**6.6 PLN16/0434 - 26 - 56 Queens Parade, Fitzroy North**

1. On 2 December 2020 Council received notice of the applicant's intent to substitute amended plans for the application plans at the hearing scheduled to commence on 15 February 2021.
2. This report provides Council with assessment of the amended plans and is to be read in conjunction with the previous officer report.

**Figure 4 – Proposed Amended Fourth Floor Plan**

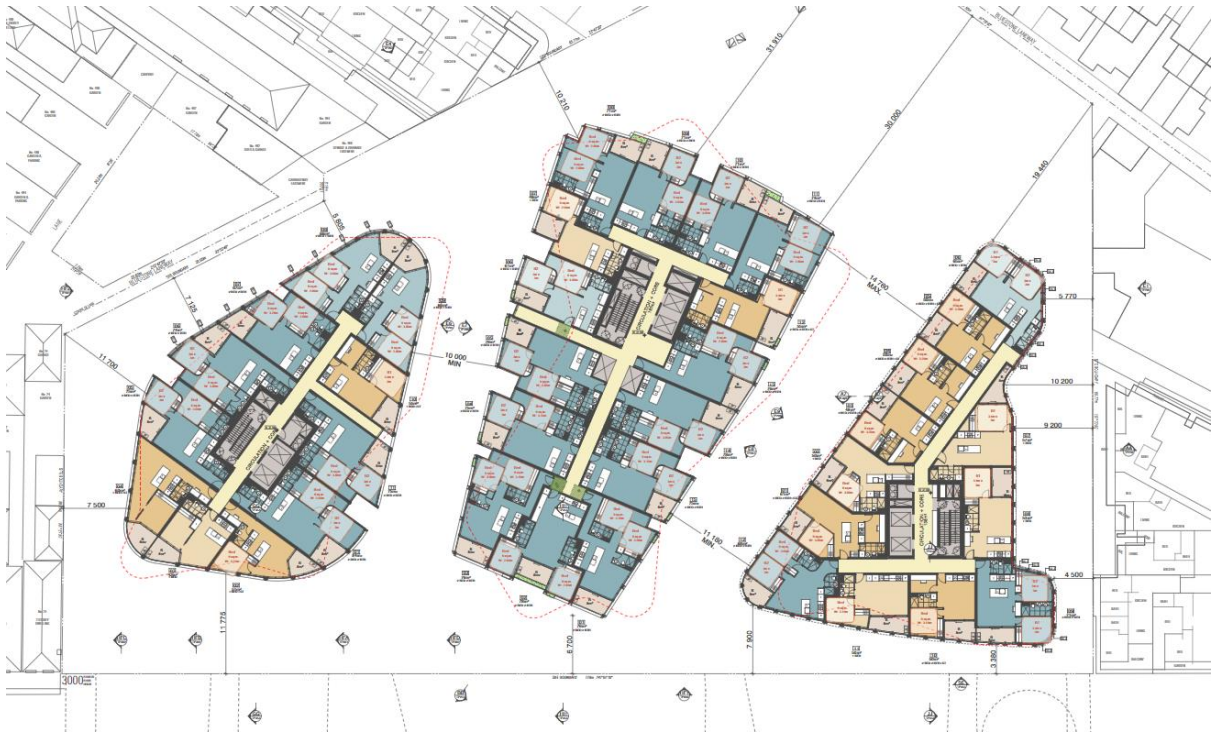
- (a) At fourth floor the three tower forms are clear of perimeter built form
- (b) Setbacks generally same as original application plans;

**Figure 5 – Proposed Amended Tower 1 Elevation**

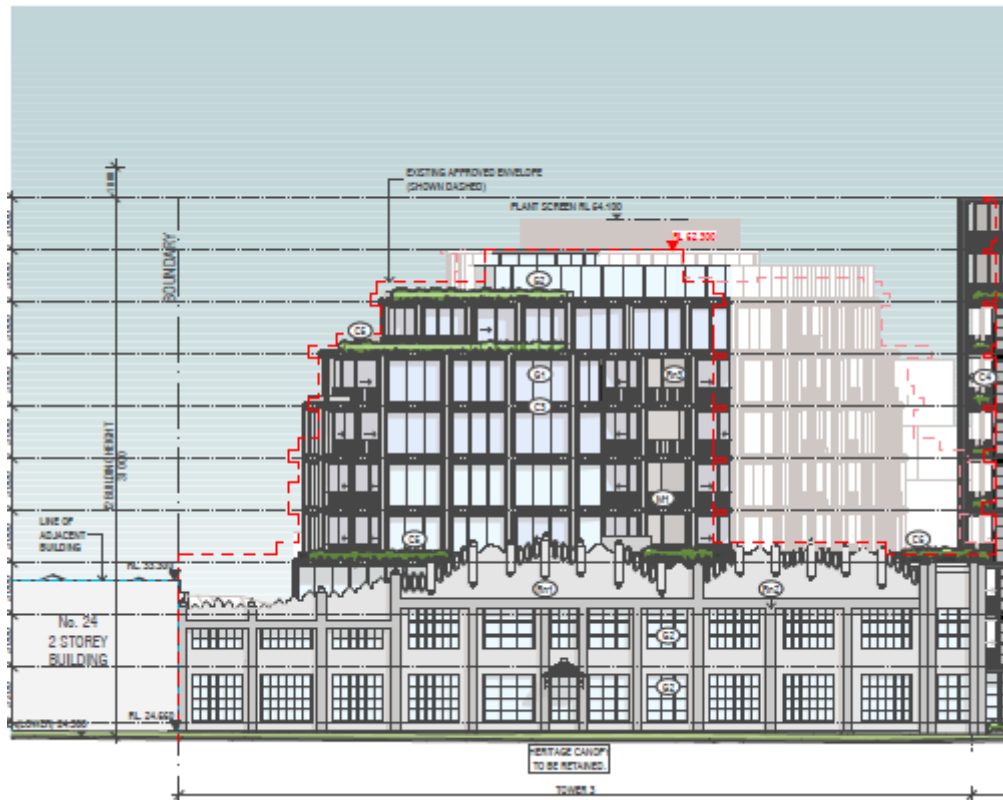
22. No change to the overall height of Tower 1, proposed height at RL52.300 or 27.7m to the top of the building and RL54.1 or 29.5m to the top of the plant.

**Figure 8 – Original Application Tower 2 Render**

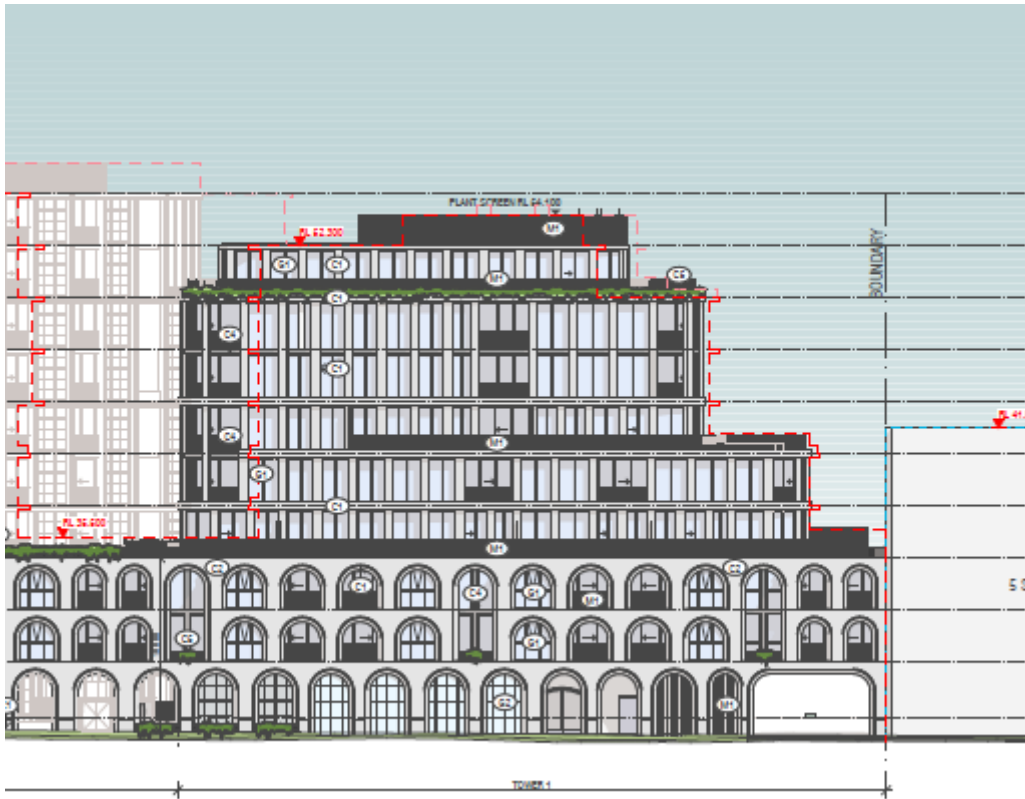
23. No change to the overall height of Tower 2, proposed height at RL55.300 or 30.9m to the top of the building and RL57.100 or 32.7 to the top of the plant.

**Figure 23 Original amendment application - Shadow at 10am**

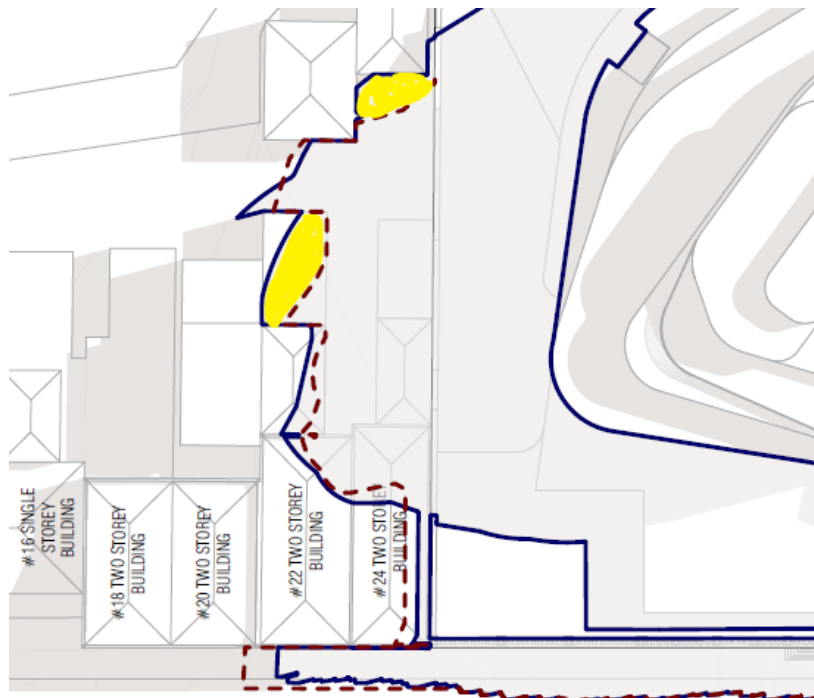
86. The shadowing impact as outlined in the previous officer report was limited to a concern regarding the properties at 22 and 24 Queens Parade at 10:00am. The affected area shown in yellow below.

**Figure 24 Amendment application - Shadow at 10am**

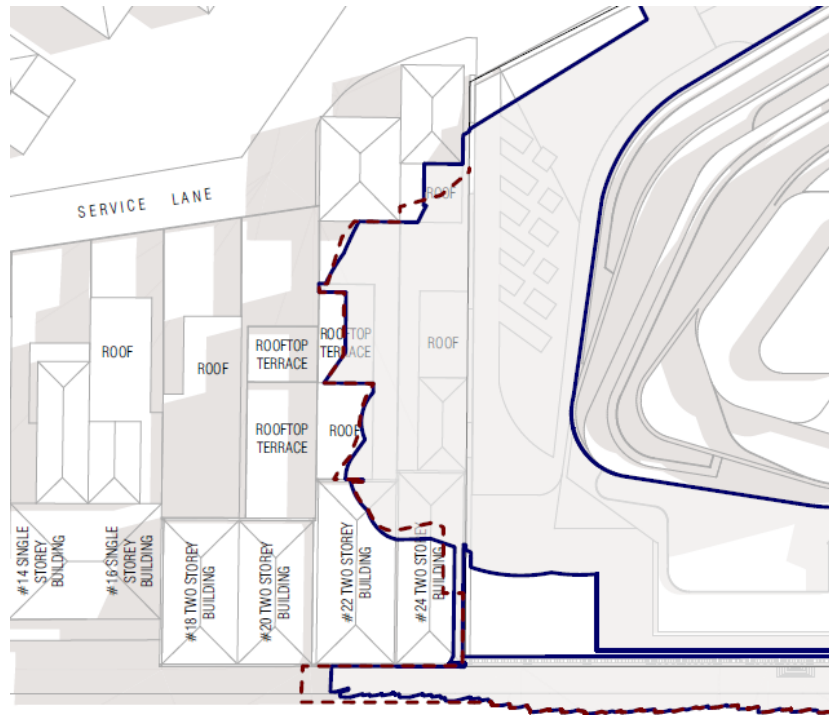
87. New shadow diagrams have been prepared which now show that shadows are generally consistent with the already approved scenario raising no further concern with shadowing impact.

88. Off site amenity impacts have been satisfactorily addressed satisfying this ground of refusal.

**Figure 26 – Proposed Amendment Studio Type 1**

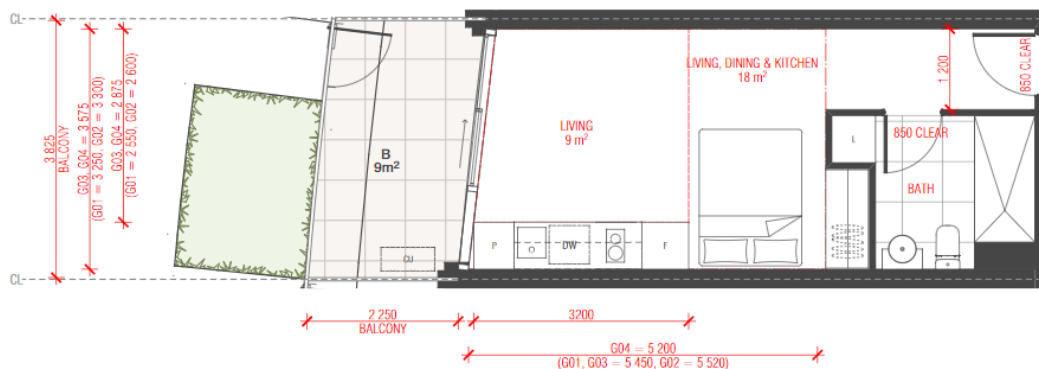
98. There are four Type 1 studio apartments located at ground floor of Tower 2 orientated to the north. This studio appears to be one of the smaller offering and the floors plans show that the 'living area' immediately abuts or overlaps the 'bedroom' area.

99. The amenity afforded to these four dwellings is not acceptable and they should be deleted. The deletion of these dwellings affords an opportunity to replace this floor area with ground level communal facility which would accord with the advice from MR McGauran who advocates for better connected communal space.
100. Studio type 5 and 6 have similar internal layout issues to those expressed for type 1, there are 10 such apartments and should be deleted with the floor area absorbed into the neighbouring dwellings.

**Figure 28 - Proposed Amendment Studio Type 5 & 6**

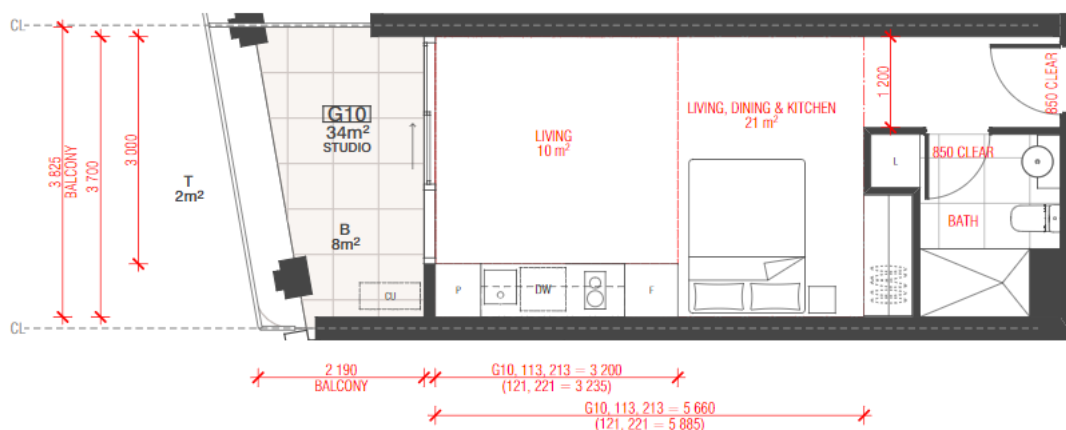
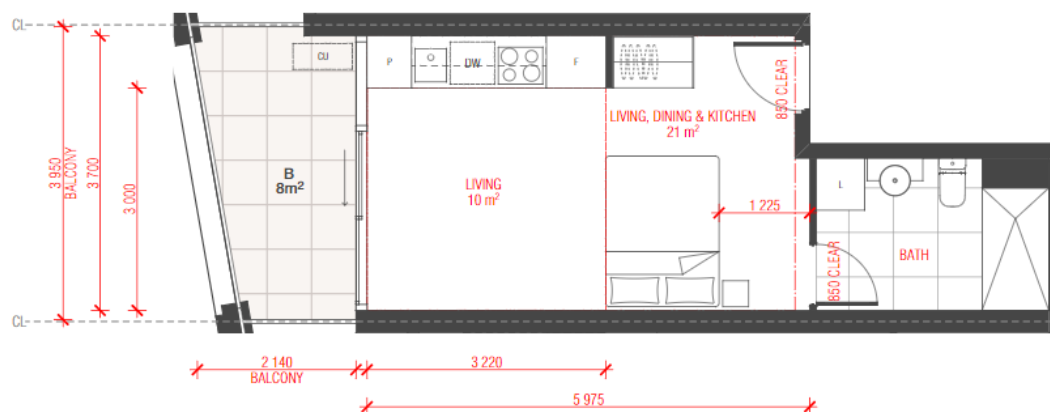
101. When assessing the functional layout of the dwellings, borrowing from clause 58, Living area dimensions (excluding dining and kitchen areas) should have a minimum width of 3.3m and a minimum area of 10sqm for a Studio or one bedroom dwelling and minimum width of 3.6m and minimum area of 12sqm of two or more bedrooms. The proposed layouts show the minimum square metres has generally been provided across the units.

- (g) Each bedroom with either minimum dimensions of 3 metres by 3 metres or a minimum area of 9 square metres provided one side of a rectangle that fits in the bedroom is no less than 2.8 metres. Each change to the dimensions or area of a bedroom must be absorbed within the building envelope.
- (h) **Deletion of dwellings G01- G04 (Tower 2) and use of this space as a communal amenities facility.**
- (i) **Deletion of Studio types 5 & 6 from the plans;**

**Figure 30 Existing Endorsed Plan – Level 1**

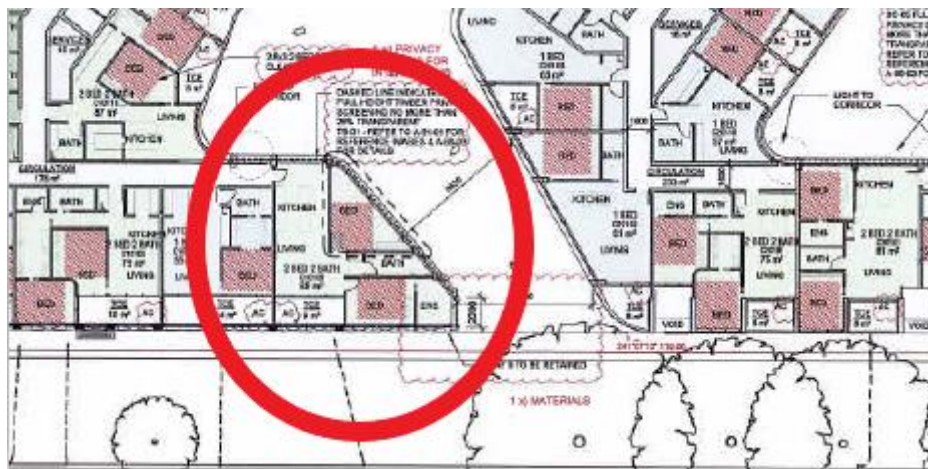
111. The interface with the rear of the office area and apartments will partly obstruct outlook however the balconies will have views to the south east and are considered to be an acceptable outcome.
112. The rear of the office building will be screened maintaining privacy raising no interlooking issues.

**Figure 31 – Proposed Amendment Level 1**

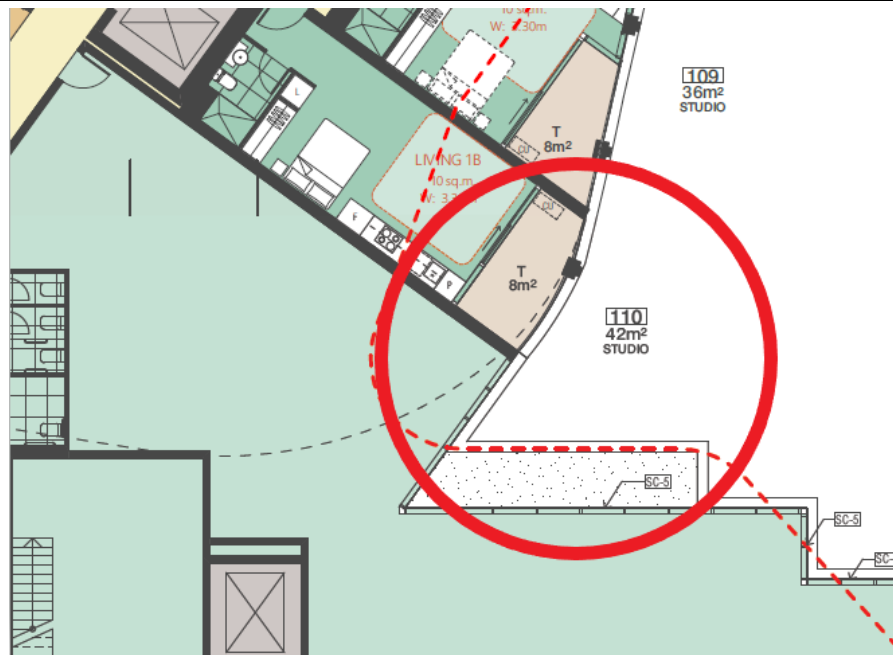
113. At the elbow where Towers 2 & 3 meet creates a pinch point between apartments (Towers 2 & 3) 109 & 115 and 209 and 215.
114. The plans detail that apartments 115 and 215 will have the northern elevation screened with fritted glass which while providing screening to this interface also allows for daylight into the bedrooms.
115. As outlined previously outlined and subject to the confirmation that all habitable spaces including bedrooms meet best practice for daylight, this outcome is considered to be acceptable.

**Figure 32 - Proposed Amendment Basement 1 Plan**

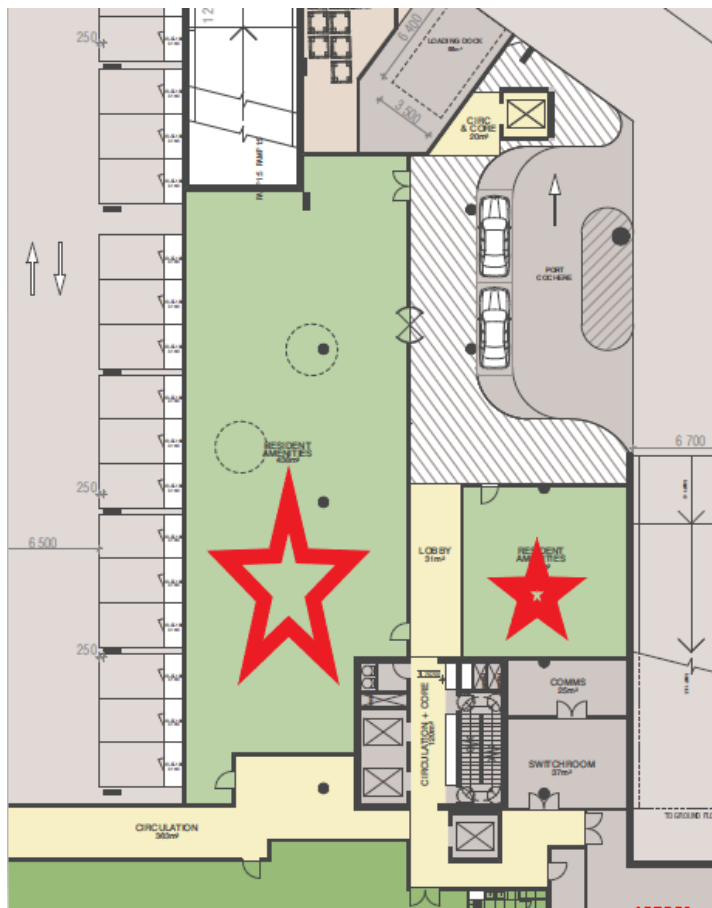
116. The plans continue to show two areas of resident amenities located in Basement 1. No information regarding how these spaces will be fitted out as has been provided however is anticipated that these spaces would be used as yoga room, library, dining, gaming type spaces as outlined in the submitted acoustic report. These spaces have no access to daylight other than two skylights as shown in the figure below.

117. Concerns regarding the lack of daylight and natural ventilation have not been addressed. A condition as discussed earlier requires the deletion of 4 studio apartments adjacent to the northern pavilion. By providing a second communal amenities area above ground and further supplemented by the amenities and communal outdoor space at level 8 Tower 1 the proposal is considered to be acceptable.

**Figure 35 – Original Application Mr McGauran Ground Floor Mark Ups**

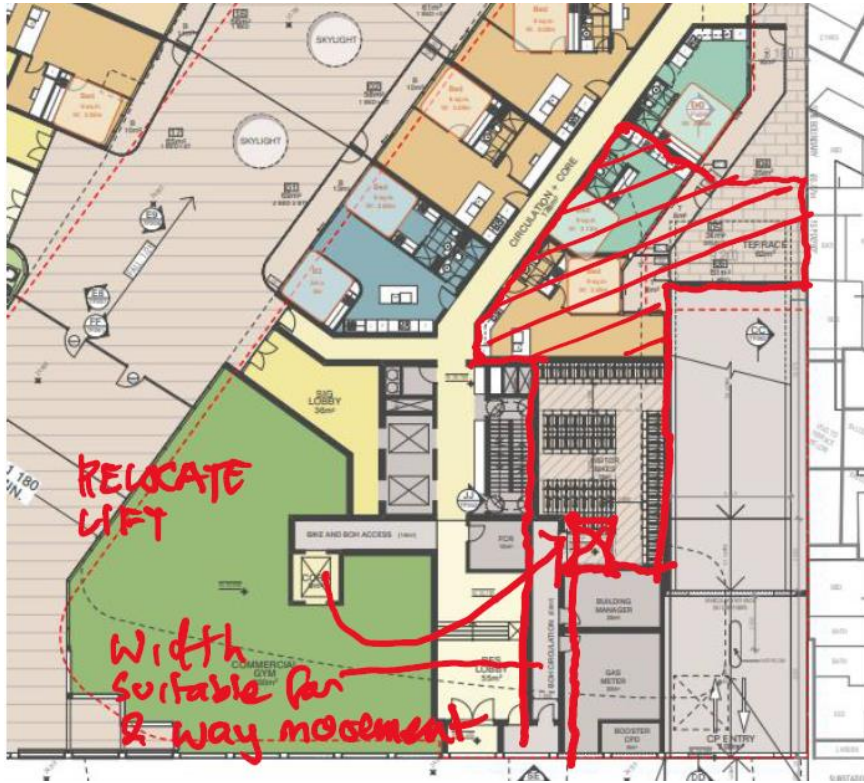
- (b) Expand ground level bicycle storage and relocate a substantial amount of basement level 2 bicycle storage to ground level and basement 2 level storage to basement level 1;

**Figure 39 – Proposed Amended Basement 2 Plan**

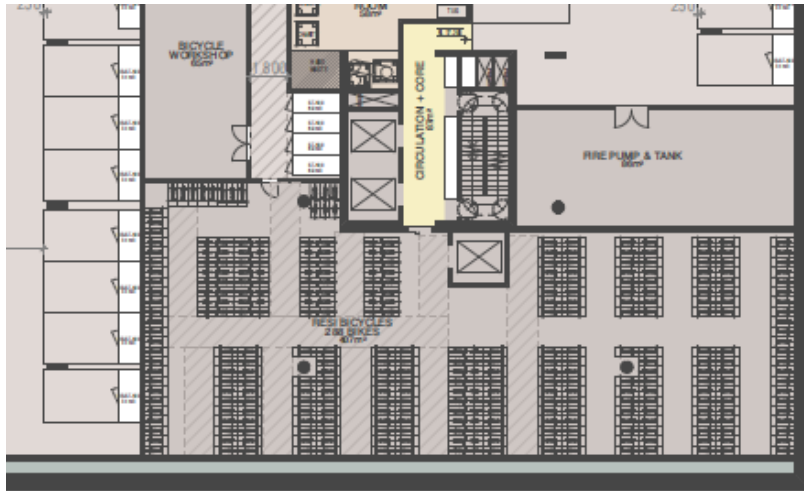
167. The second bike parking area has not been moved to basement 1 as suggested by Council's consultant urban designer, however the layout and design has been improved to better facilitate access.

169. It is suggested that these could form conditions on any permit granted.
170. Council's contract Urban Designer has also reviewed the plans and while these have not addressed all the recommendations outlined within his report, they are acknowledged as improvements. On balance and subject to the conditions above, the bicycle parking arrangements are acceptable
